[Docket No. 95–CE–14–AD]

#### Airworthiness Directives; Cessna Aircraft Company 150 and A150 Series and Models 152 and A152 Airplanes

**ACTION:** Notice of proposed rulemaking (NPRM).

FIGURE 1  
MID-AMERICA DWG No. 1001  
(STC SA1371 SW)

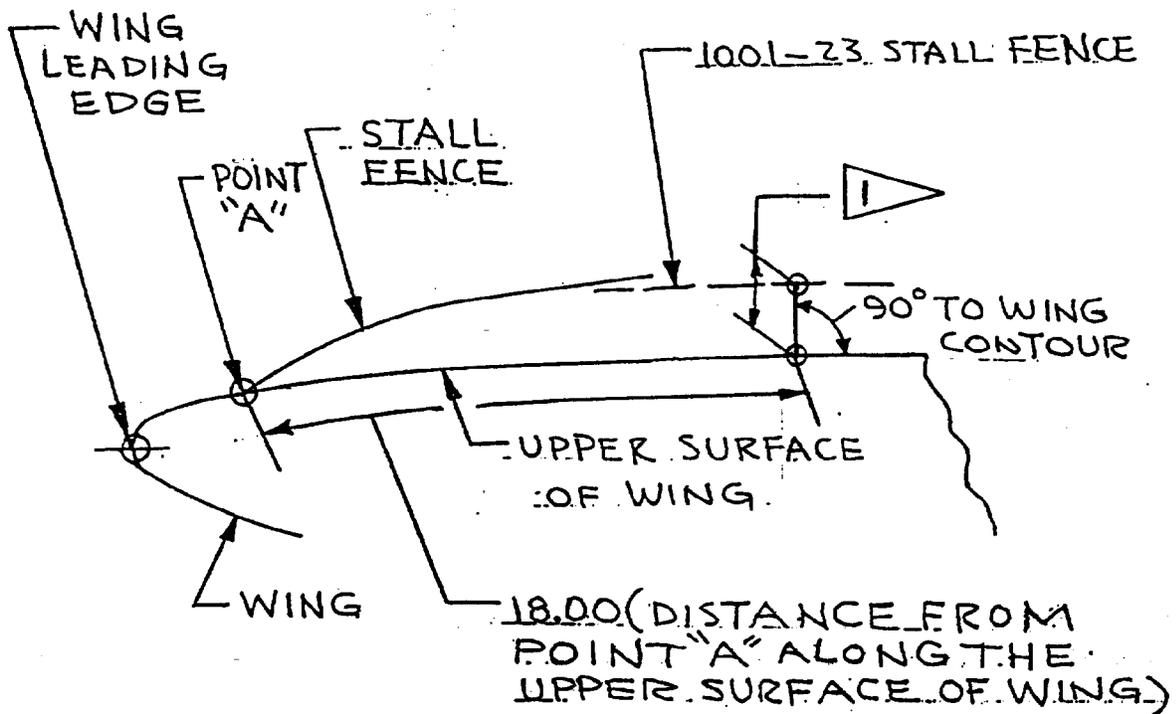
installed in accordance with Supplemental Type Certificate (STC) SA1371SW. This kit includes a wing leading edge cuff and stall fence on each wing that is installed on the top of the wing chordwise in line with the aileron/flap juncture. The wing stall fence on this Cessna Model 152 airplane measured 1.625 inches in height at its trailing edge and maintained that height through approximately 70 percent of the fence's length, gradually tapering to the contour of the wing's leading edge.

The FAA approved the fence height of the Bush Conversions, Inc., STOL kit at a height of 1.16 inches (plus or minus .12 inches) for Cessna 150 and A150 series and Models 152 and A152 airplanes. Mid-America Drawing No. 1001 references this height and is included as part of STC SA1371SW. Mid-America Drawing No. 1001 is included as Figure 1 of the proposed AD.

(a) Measure the height of the wing stall fence at its trailing edge to ensure that the height does not exceed 1.28 inches. (See Figure 1 of this AD).

1 ▽ IF STALL FENCE IS  $1.16 \pm .12$  HIGH, THAT IS CORRECT HEIGHT FOR STALL FENCE. IF GREATER THAN 1.28 HIGH, REMOVE STALL FENCES AND INSTALL THE CORRECT ONE.

(b) If the wing stall fence height exceeds 1.28 inches, prior to further flight, install a smaller fence in accordance with instructions obtained from the Wichita Aircraft Certification Office (ACO), FAA, 1801 Airport Road, Mid-Continent Airport, Wichita, Kansas 67209.
